No: 26-083

DAUPHIN COUNTY SUBDIVISION/LAND DEVELOPMENT REVIEW REPORT

Plat Title Proposed Building Addition at Best Western Plus

Date Received 08/07/26 Staff Review 08/20/26 Official County Review 08/20/26

DATE: 08/04/2026 **DWN BY: MLS** **DWG NO.: 25-0531** **SHEET 01 OF 10**

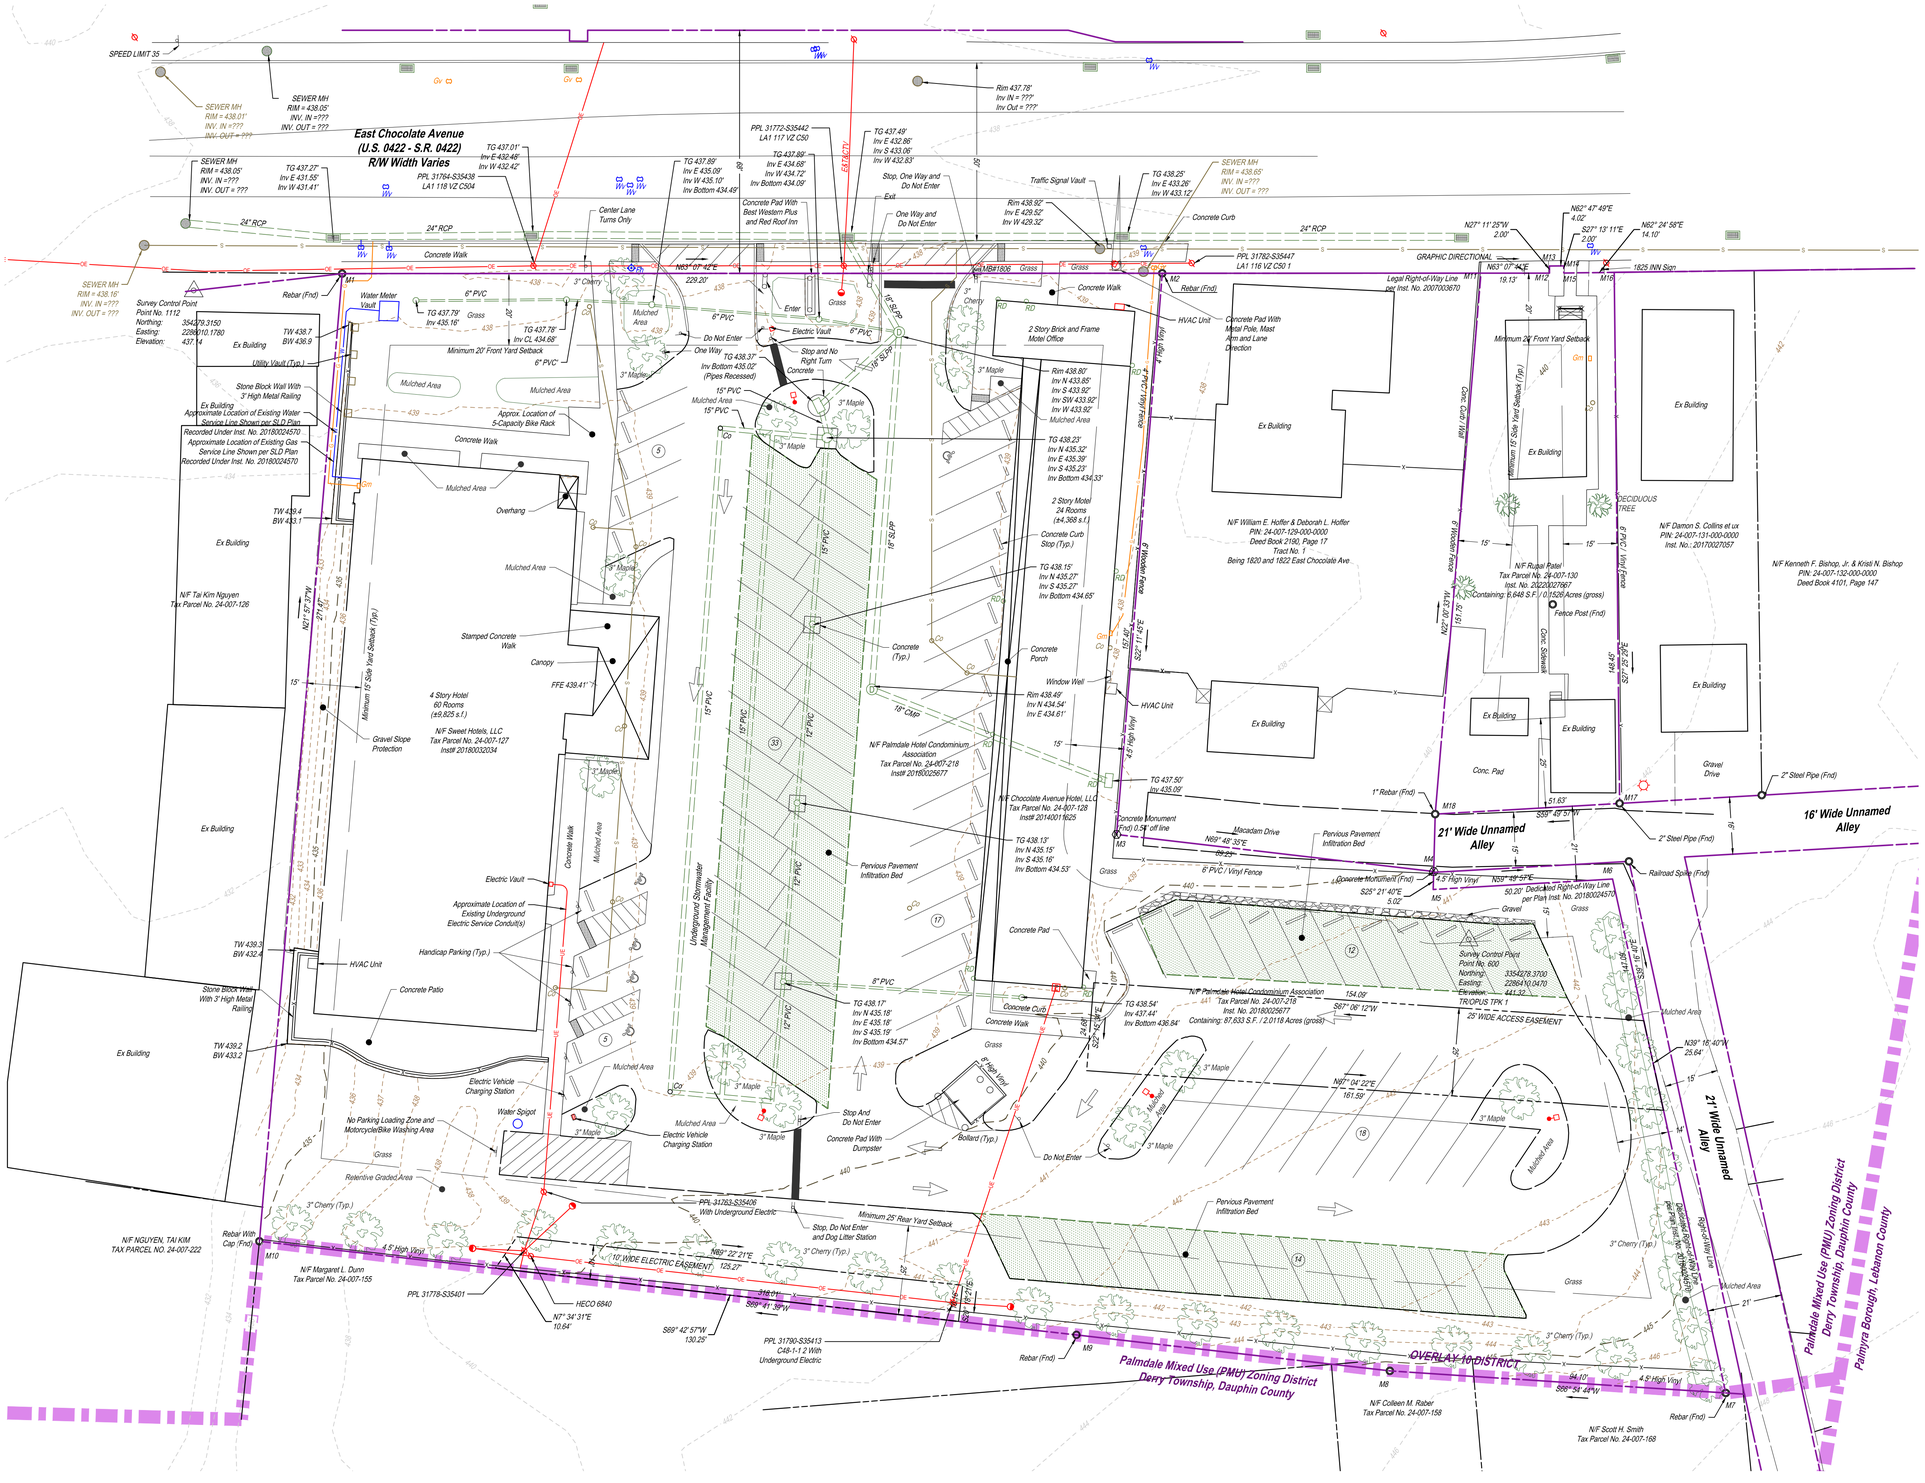
e. DEP sewage planning module [S/LD – §185-13E(5b)]
   f. Lighting plan and professional certification [S-LD §185-33E]
2. Provide correct addresses in the area and bulk regulations chart on Sheet 01. In addition, include parcel 24-007-130 in the parcel listing, as well as existing and proposed acres for each parcel/address included on the chart.

SUBDIVISION PLAN

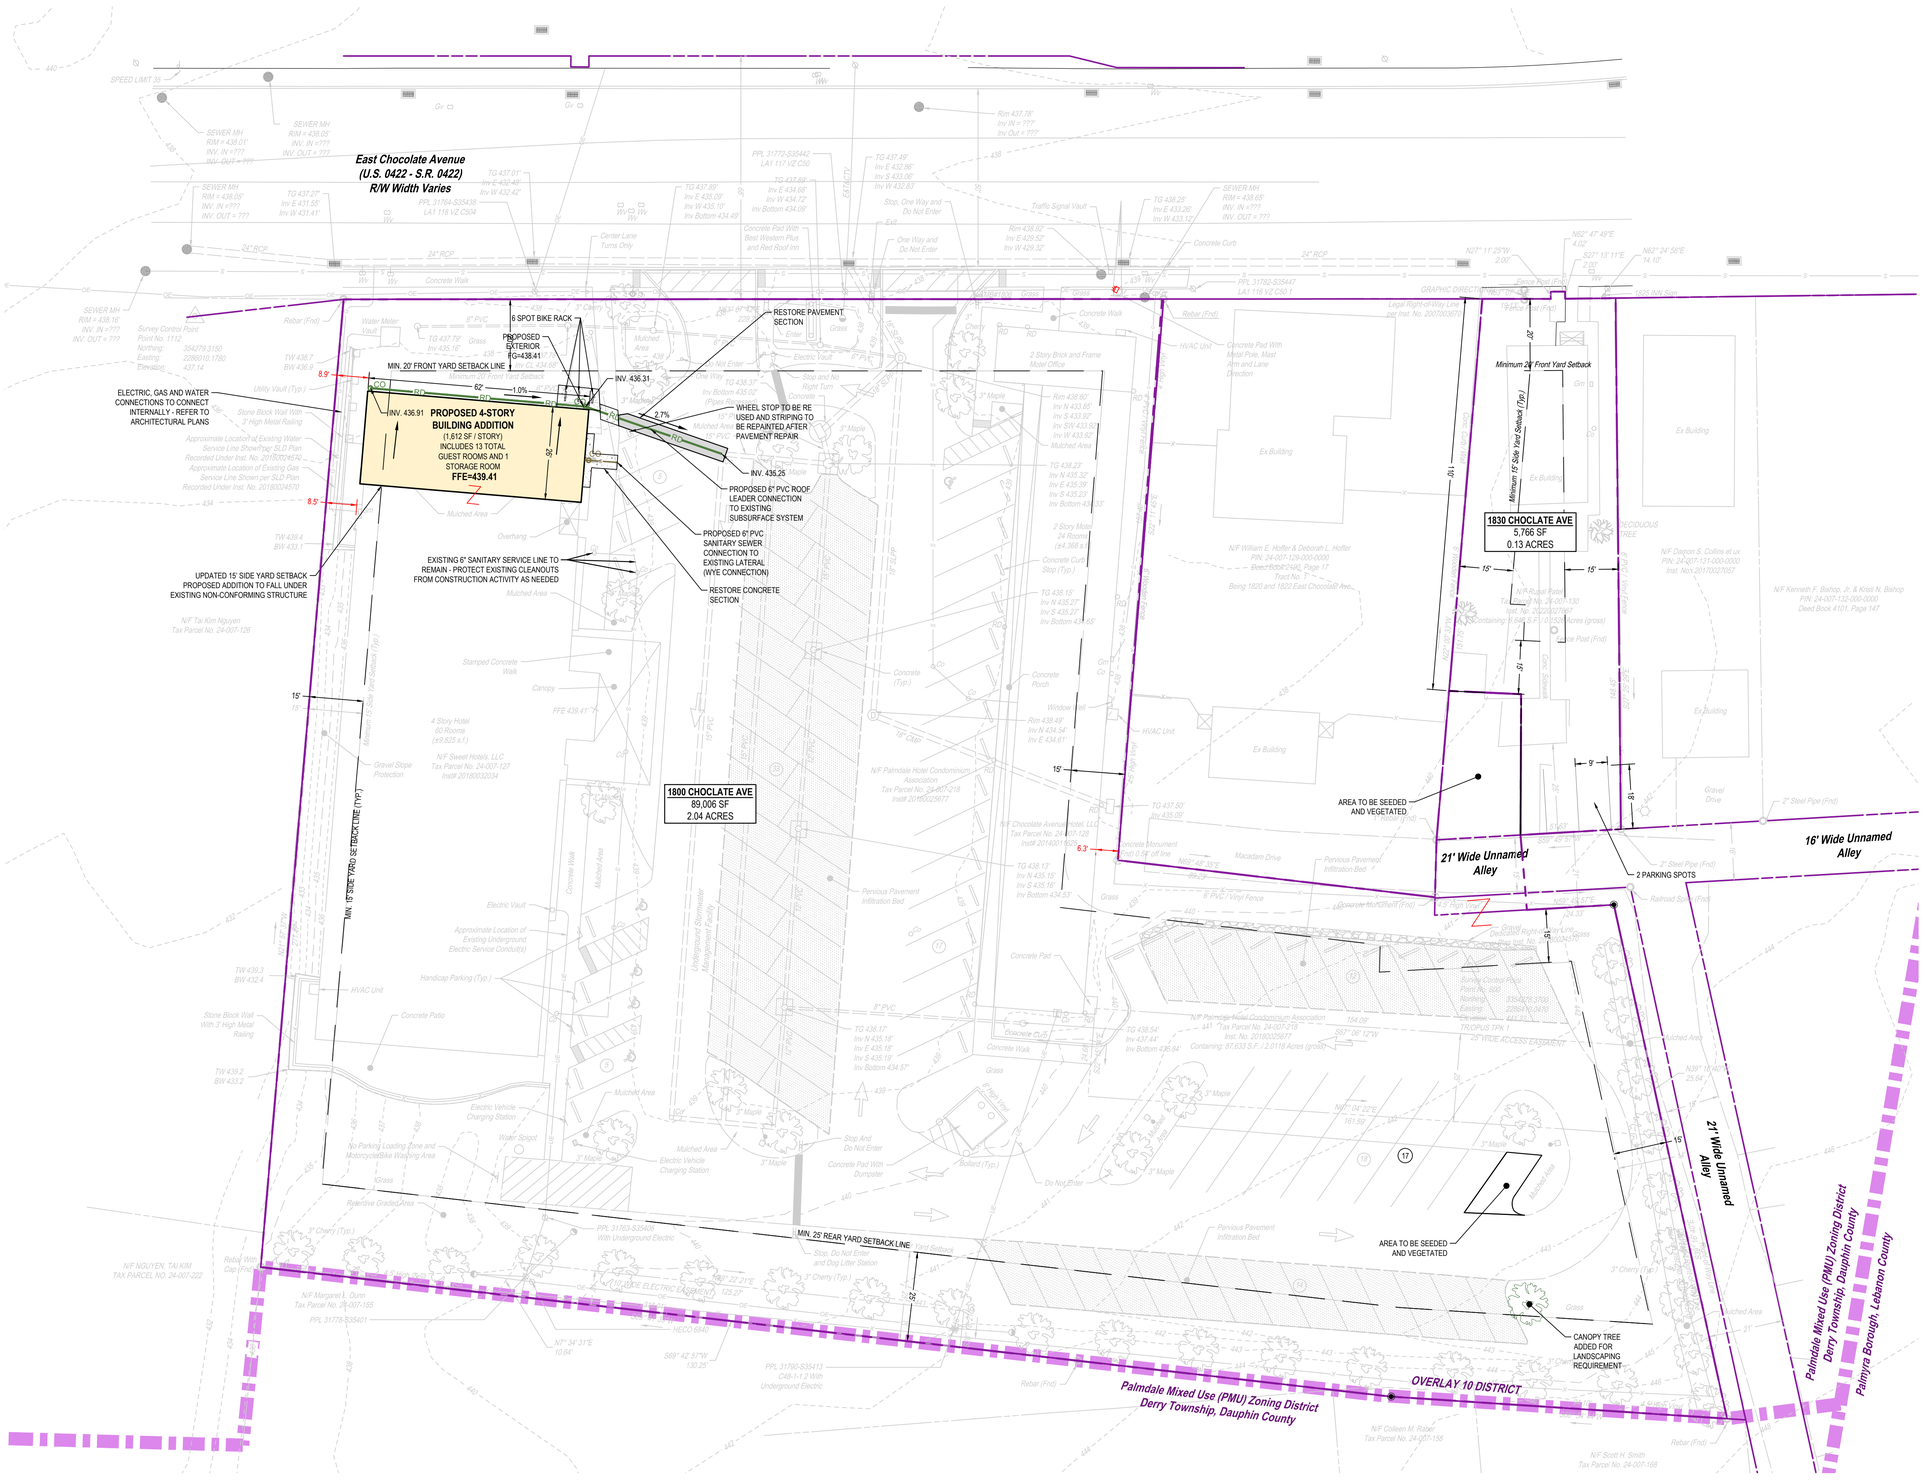
3. Show appropriate monument/marker(s) for adjusted property line of parcel 24-007-130 [S-LD §185-13E(4a)(49)].
4. Provide data substantiating minimum fire hydrant flow, availability, recharge and duration requirements [S-LD §185-12D(4g); §185-36B (7)].
